County of Fairfax, Virginia

STAFF REPORT ADDENDUM

**SPECIAL EXCEPTION AMENDMENT SEA 91-S-031
AND 2232-S14-9**

PROPOSAL: The applicants request an amendment of a special exception for an electric substation to permit the addition of a 140-foot tall monopole (telecommunications facility) and a modification in land area and have filed for a review by the Planning Commission to determine whether the proposed 140-foot monopole camouflaged as an evergreen tree and related equipment compound satisfies the criteria of location, character, and extent pursuant to Section 15.2-2232 of the Code of Virginia, as amended.

Figure 1: Telecommunications facility compound area with 140-foot tall treepole, Source: SEA Plat, Sheet A-1

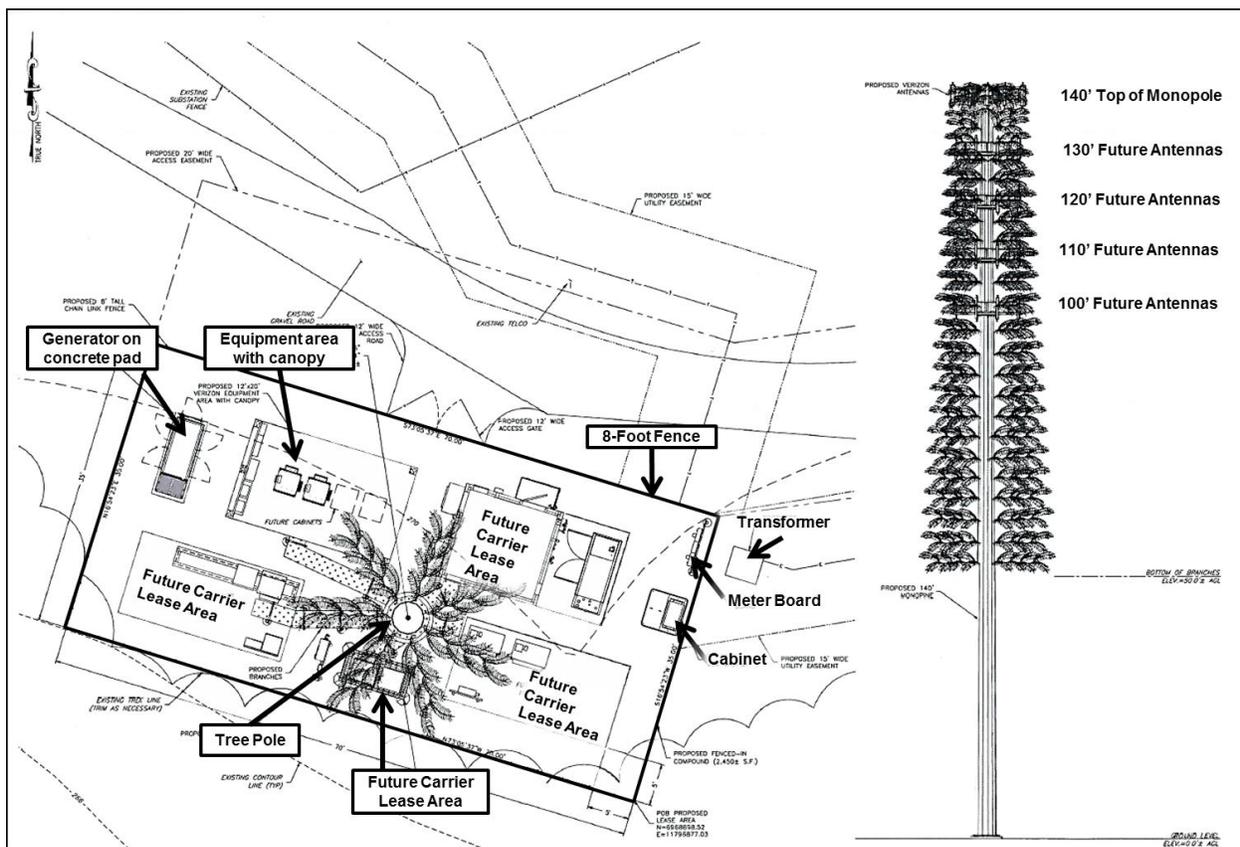
Sheet A-1, Compound Plan and Elevation: This sheet was revised to show the proposed 140-foot tall monopole camouflaged as an evergreen treepole, as shown in Figure 1. There is no change to the height of the structure or to the height of the elevations for the five antennas. The revised sheet now shows the treepole in the equipment compound area with artificial foliage used to screen the monopole. There is no other change to the equipment compound area.

In accordance with Objective 42, Policies g through i and as shown in Figure 1, the applicants are proposing to collocate up to five carriers on the proposed treepole. Such collocation ensures that the proposed 140-foot tall monopole is not greater in height than necessary to allow for collocation based on service area requirements while still reducing the visual impact of the facility by camouflaging it as a tree. The proposed height is consistent with surrounding transmission towers that are 142 feet in height.

Figure 2: Proposed 140-foot tall treepole and surrounding utility towers, Source: SEA Plat, Sheet A-2

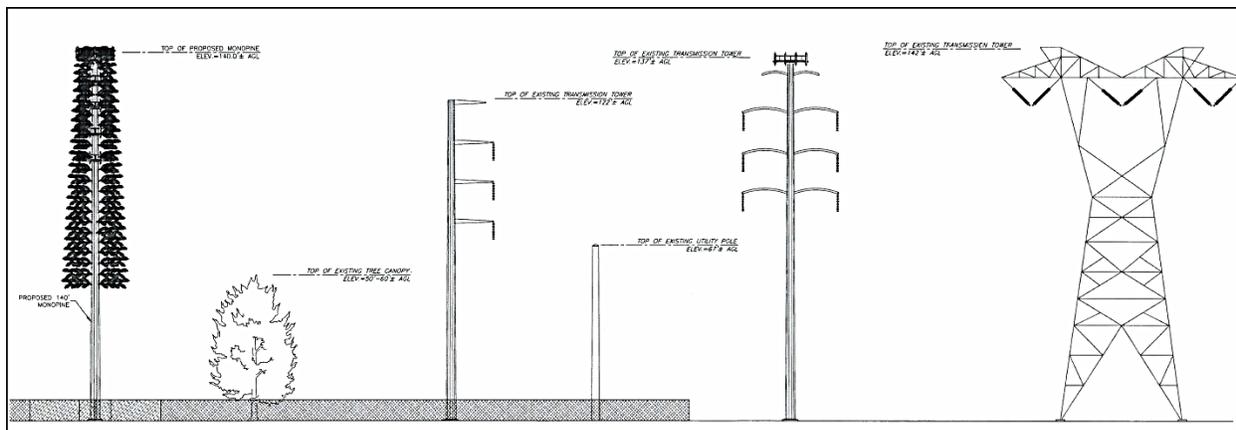
Sheet A-2, Tower Elevation Details: This sheet was revised to show the proposed tree pole and the relationship of its height to surrounding transmission towers, as shown in Figure 2. The height of the top of the monopole is still proposed to be 140 feet.

June 3, 2015, to show the existing coverage and coverage with the proposed telecommunications facility. Milestone Communications' objective with the proposed telecommunications facility is to be able to provide coverage and capacity in the Clifton area, specifically along Main Street in the Town of Clifton and to Clifton Creek Drive. The telecommunications facility will resolve the need for adequate coverage in the area surrounding the subject property and will ensure adequate overlapping coverage between and among the carrier's existing sites in the area and for other telecommunication carriers in the future. Ultimately, the facility will provide residents and commuters with better quality service and diminished dropped calls. In addition to the applicants' antennas, as shown in Figure 1, collocation of up to four additional wireless carriers are feasible on the treepole in an integrated placement of antennas at 10-foot intervals, in accordance with Objective 42, Policies g, k, and o, which recommend collocating facilities operated by different service providers on single sites and/or structures. Milestone Communications indicated that 140 feet is the minimum extent feasible to meet wireless coverage objectives and accommodate up to five telecommunication carriers. The proposed height is inclusive of antennas and foliage used to screen the structure and such height is comparable with adjacent and nearby transmission structures, as shown in Figure 2.
